SERVICE BULLETIN No **16-3**

PRODUCTION CHANGE

**SUBJECT: OIL COOLER AIR DUCT
VEHICLES: 328**

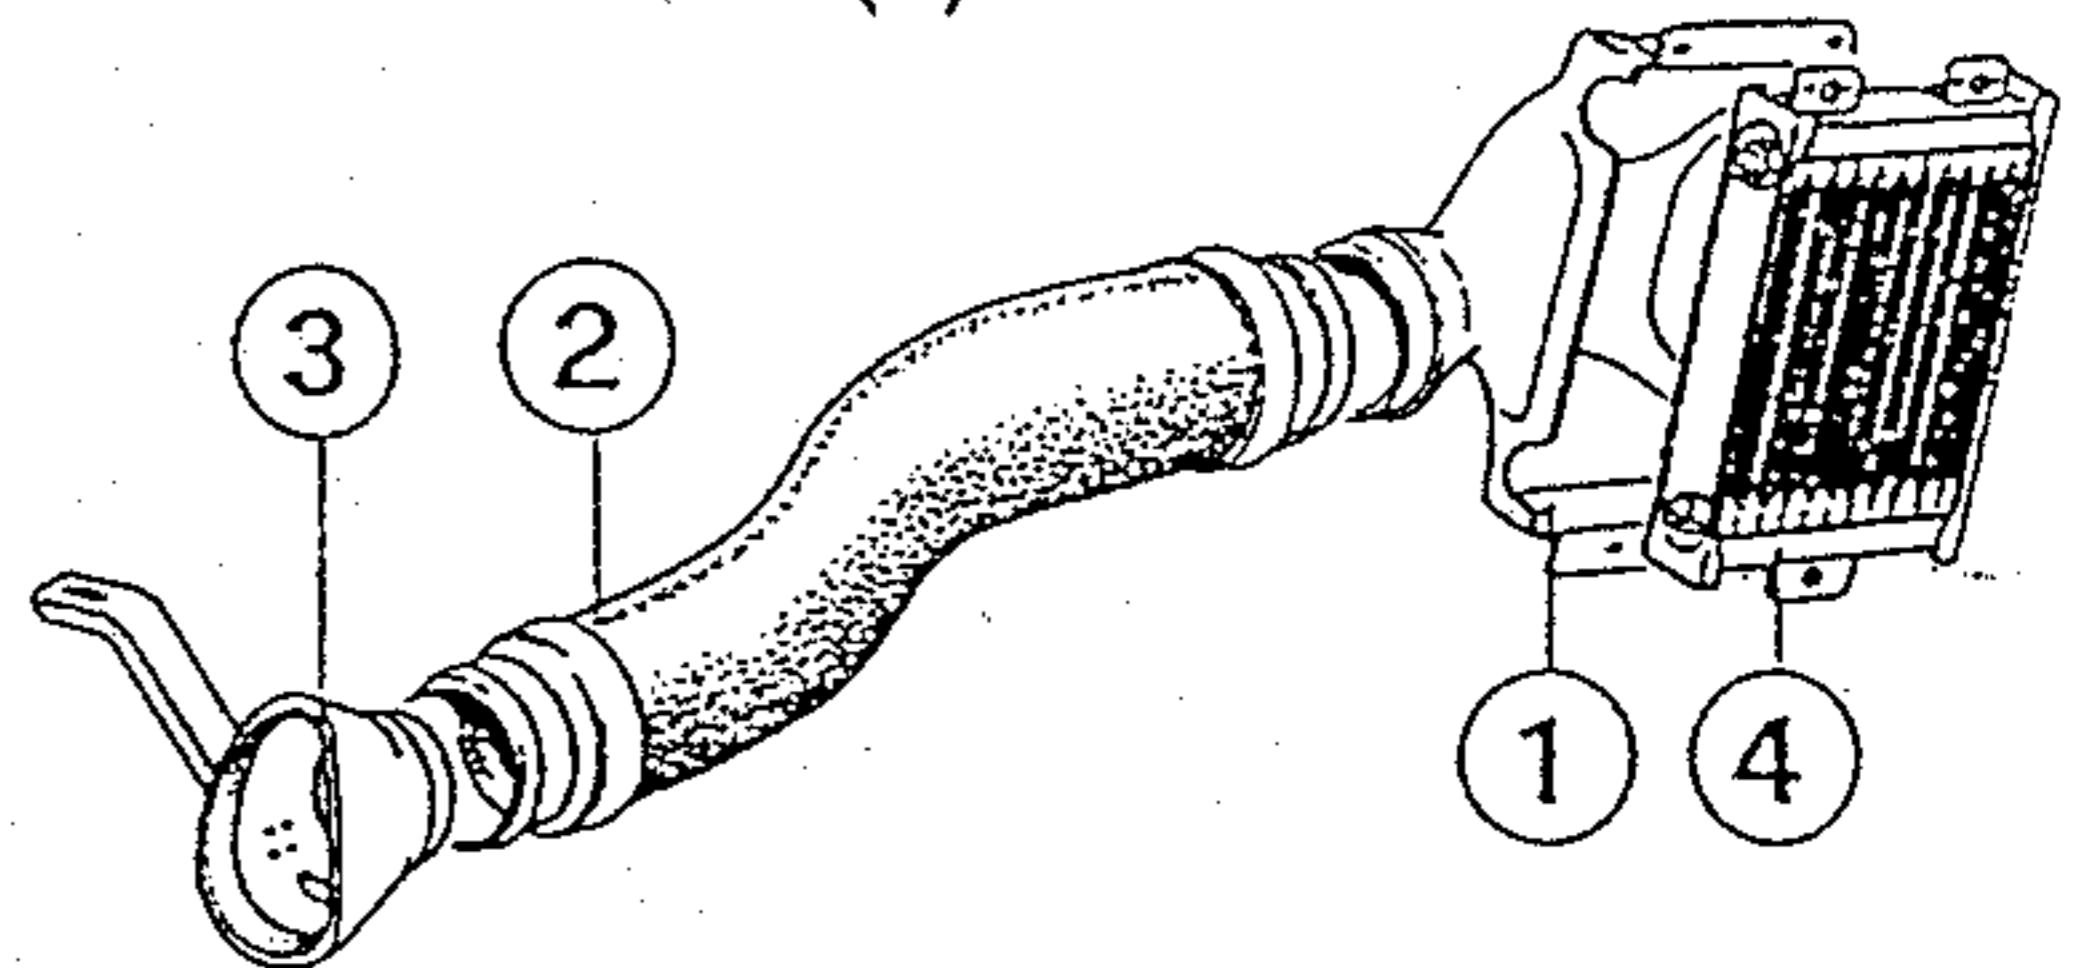
A new oil cooler air duct (3) is fitted to a new flexible tube (2) along with a modified conveyor (1). In addition, there is also installed a new oil cooler (4) P.N. 135774.

The vehicles with C.N. 75596 - 75799 - 75807 - 75810 - 75865 - 75868 - 75876 : are still assembled with a pre-modified oil cooler.

Spare parts procedures: The new oil cooler can be installed on cars with C.N. lower than 75272 but the air conveyor must be slightly adapted.
